Access Compliance Report

Public Rights-of-Way

(Curb Ramps)

Intersection ID: 10039485	Main Street: TELEVISION_PL	Cross Street: N/A	Location:	E
ADA ID: C8A4250C9662	Ramp Type: PerpDiag	Initial Pass/Fail: Fail	Overall Compliance: No	Severity Score: 55

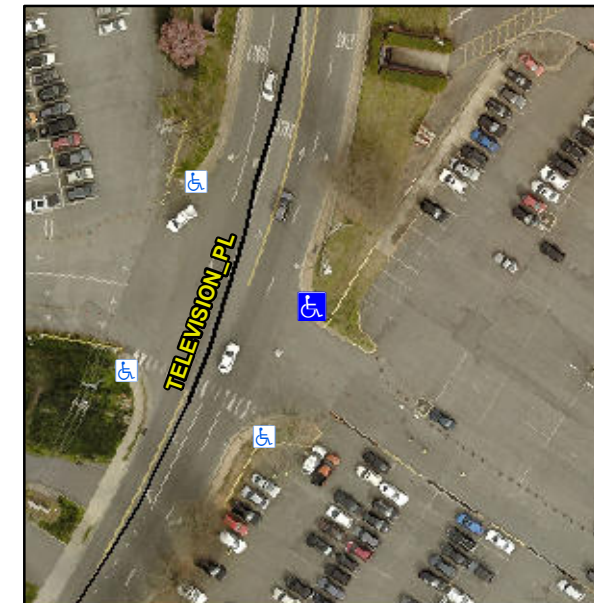
Not Found, R304.5.1, R304.2.2, R304.5.3

Compliance	Description	Data	Compliance	Description	Data
N/A	Ramp Length (in)	48.0	No	Ramp Slope (%)	9.9
No	Ramp Width (in)	32.0	No	Ramp XSlope (%)	9.6
N/A	Flare Type LT	N/A	N/A	Flare Type RT	N/A
N/A	Flare Slope LT (%)	N/A	N/A	Flare Slope RT (%)	N/A
N/A	Flare Traversable LT?	N/A	N/A	Flare Traversable RT?	N/A
N/A	Landing Length (in)	N/A	N/A	DWS Provided?	N/A
N/A	Landing Width (in)	N/A	N/A	DWS Contrast?	N/A
N/A	Landing Slope (%)	N/A	N/A	DWS Length (in)	N/A
N/A	Landing X Slope (%)	N/A	N/A	DWS Full Width?	N/A
N/A	Landing Curb? (Y/N)	N/A	N/A	DWS Offset (in)	N/A
N/A	Shared Landing?	N/A			
N/A	Gutter Ponding?	N/A	N/A	Gutter Slope (%)	N/A
N/A	Gutter Lip Ht (in)	N/A	N/A	Gutter X Slope (%)	N/A
N/A	Painted X Walk1?	No	N/A	Painted X Walk2?	No
	X Walk 1 Direction	To NW		X Walk 2 Direction	To SW
N/A	X Walk 1 Width (in)	N/A	N/A	X Walk 2 Width (in)	N/A
	X Walk 1 Slope (%)	12.2		X Walk 2 Slope (%)	6.2
	X Walk 1 X Slope (%)	7.4		X Walk 2 X Slope (%)	13.2

Remove & Replace Curb Ramp With Two New Directional Ramps or Equivalent.
